## ADDENDUM NO. 1

**DATE: September 26, 2013**

Contract 13-C-00044; Howard F. Curren Gravity Thickener and Sludge Pump Replacement

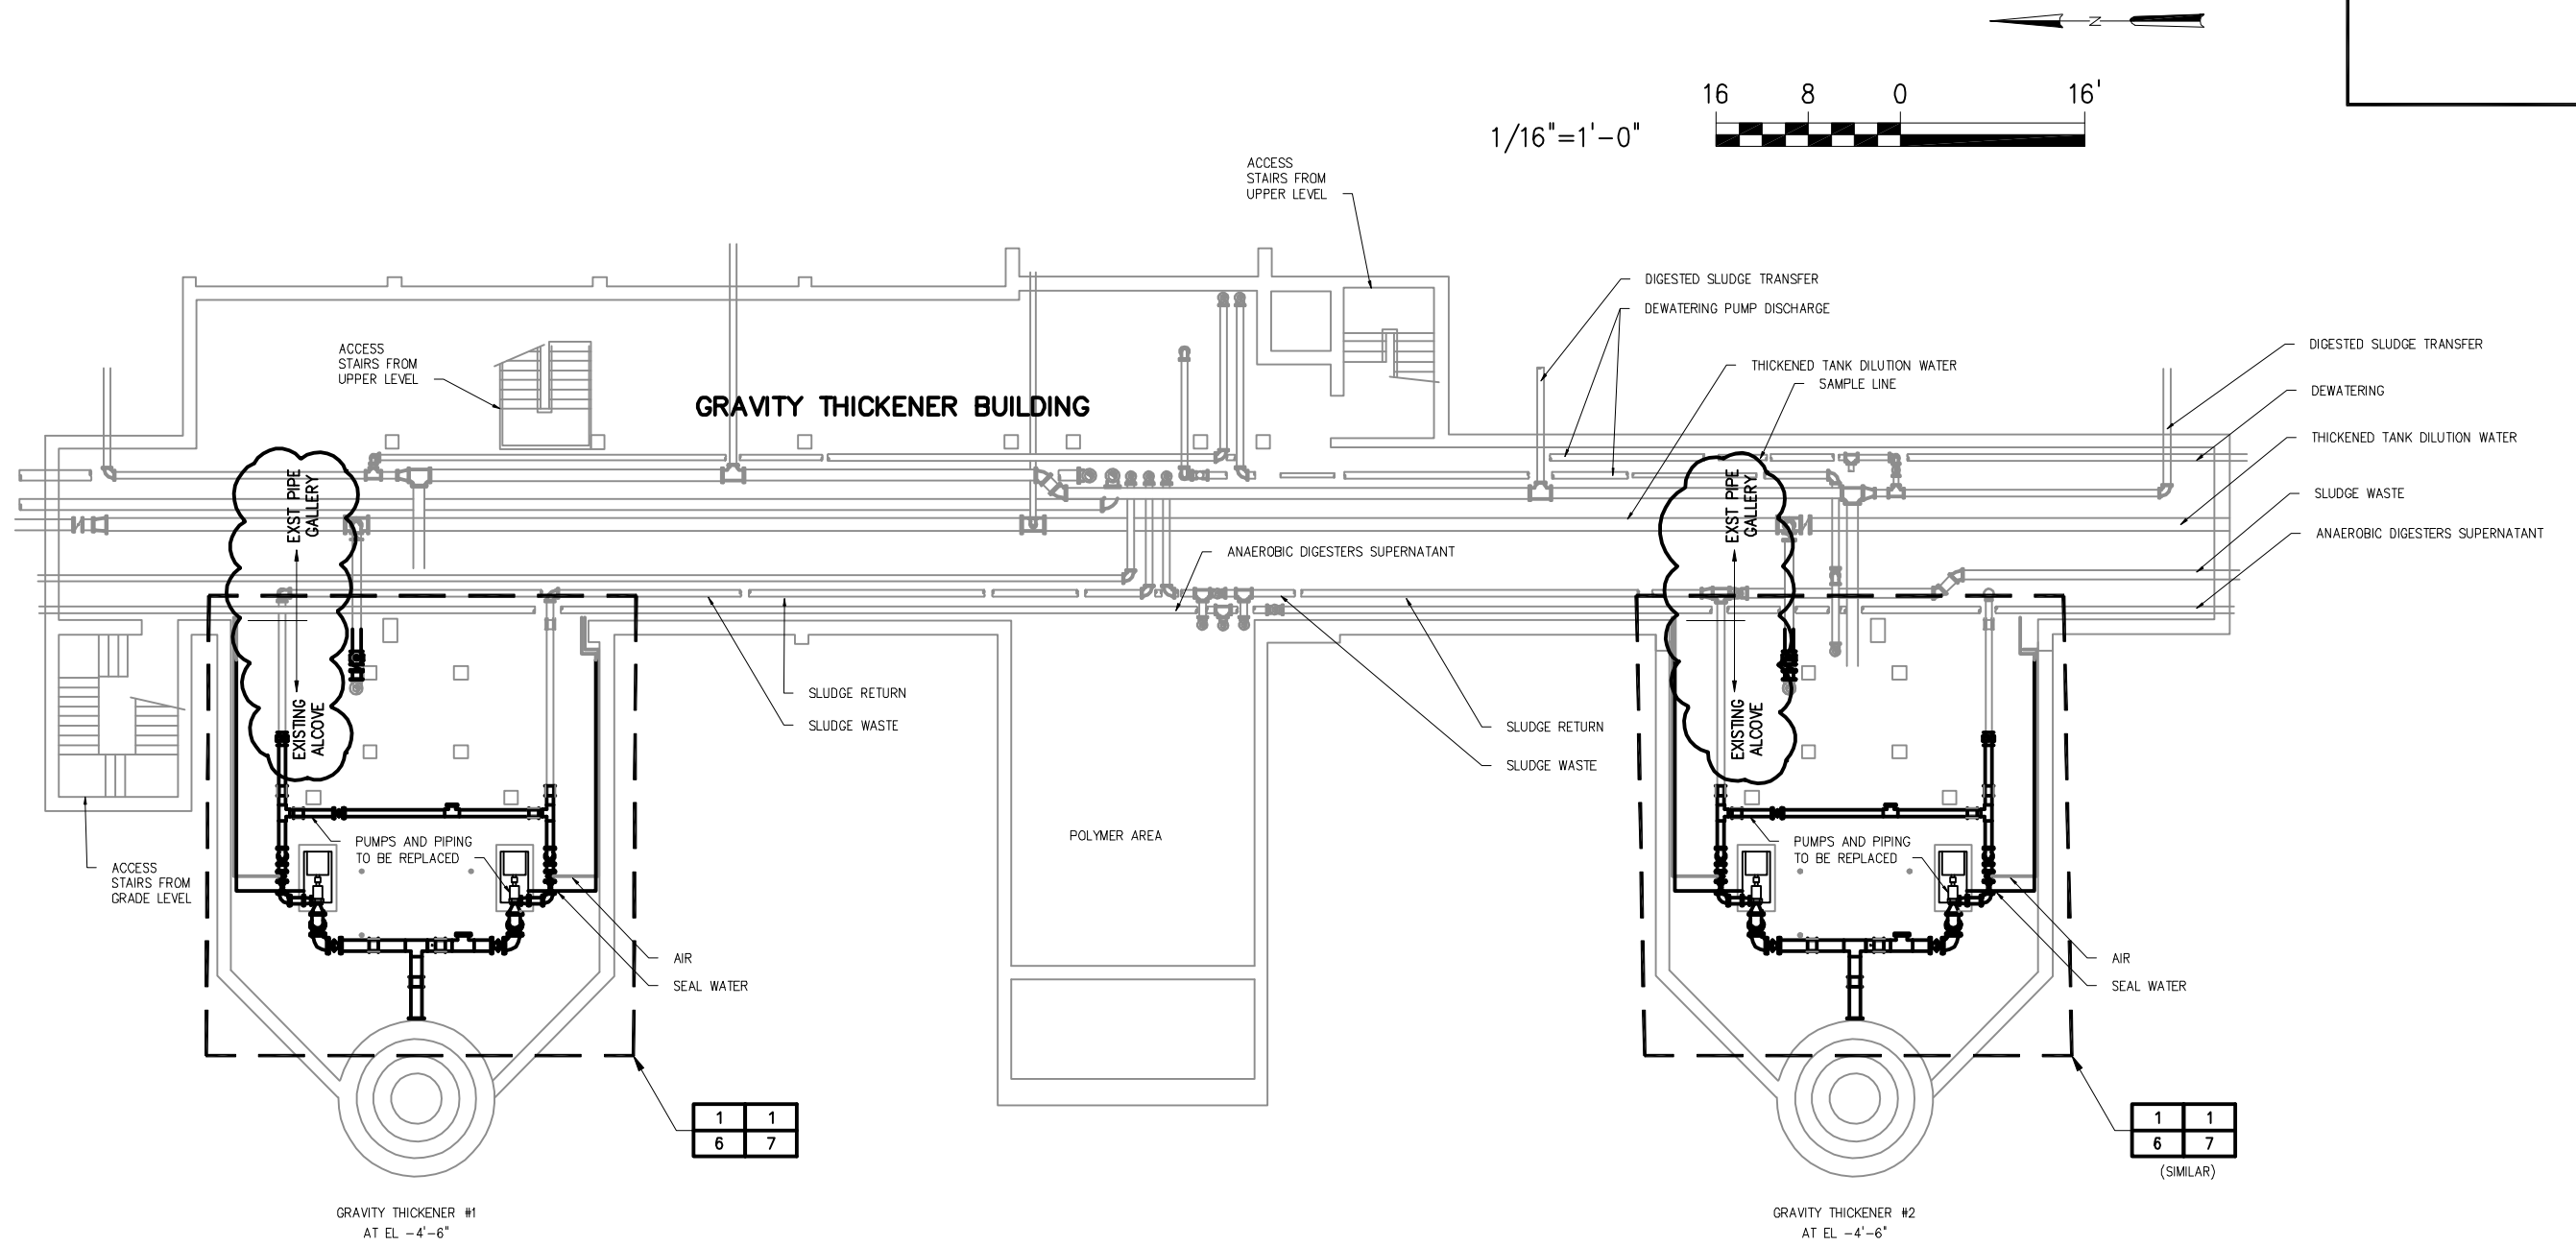
6. QUESTION: Sheet 12 of the contract plans, has two notes that say, "For the three conduits that pass through the slab at grade to lower level south of the mixer box, cut slab around conduits, install new pvc coated conduits through the slabs and form and pour slab around new and existing conduits." Please provide the existing slab thickness which will be removed and replaced, and reinforcing detail

**RESPONSE: During the pre-bid meeting held September 17<sup>th</sup>, it was pointed out that some of the four conduits for the south tank have already been replaced and the slab penetration, approximately 12" opening, already made with existing rebar left in place. The slab is about 12" thick with two layers of #5 rebar at 6" to 12" spacing. Hole in slab just needs to be formed and filled in with non-shrink grout and additional steel placement and/or dowel will not be necessary. Similar cutting away of slab around the three conduits keeping the rebar in place for the north tank is to be made. See picture below of existing conditions on south tank.**

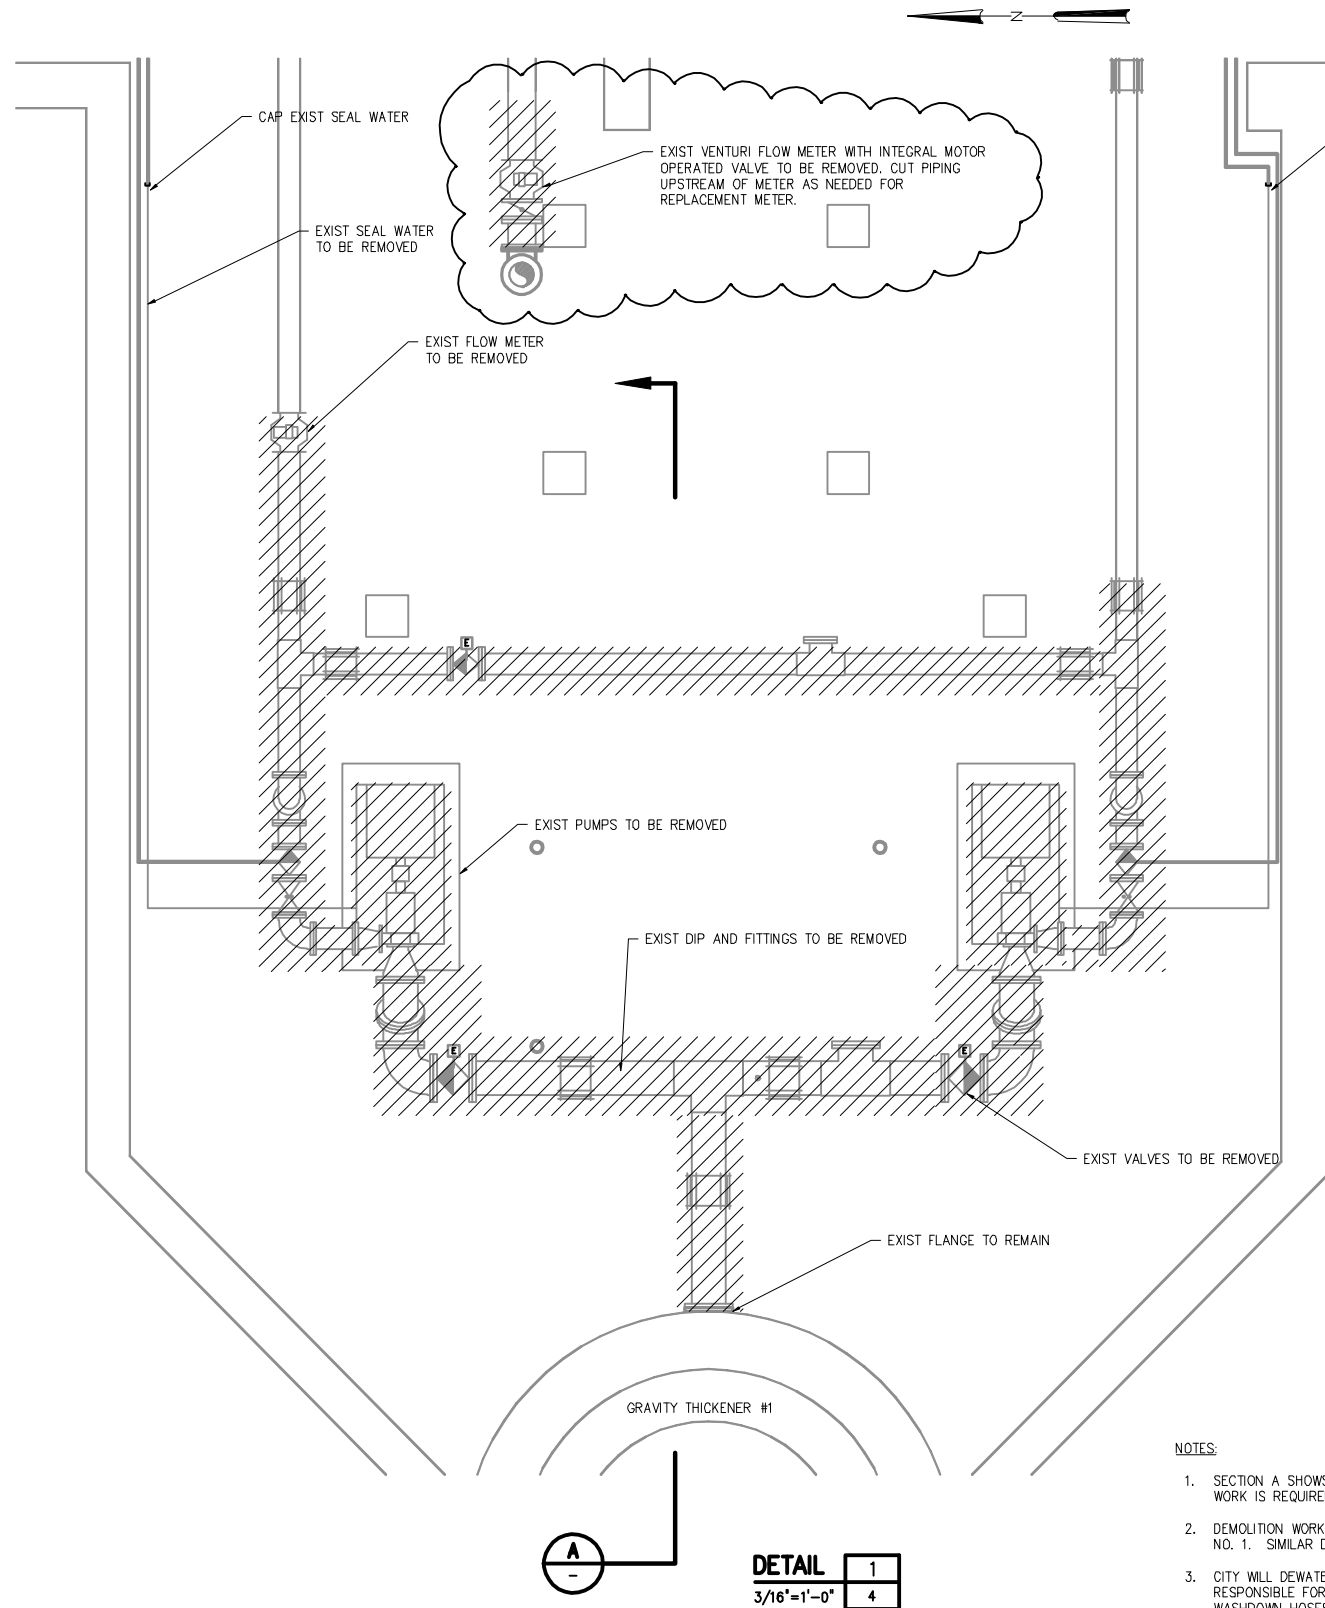
- Item 2: Replace Sheet 4 with the attached updated drawing. Designation was added to depict limits of alcove areas for purposes of estimating painting requirements.
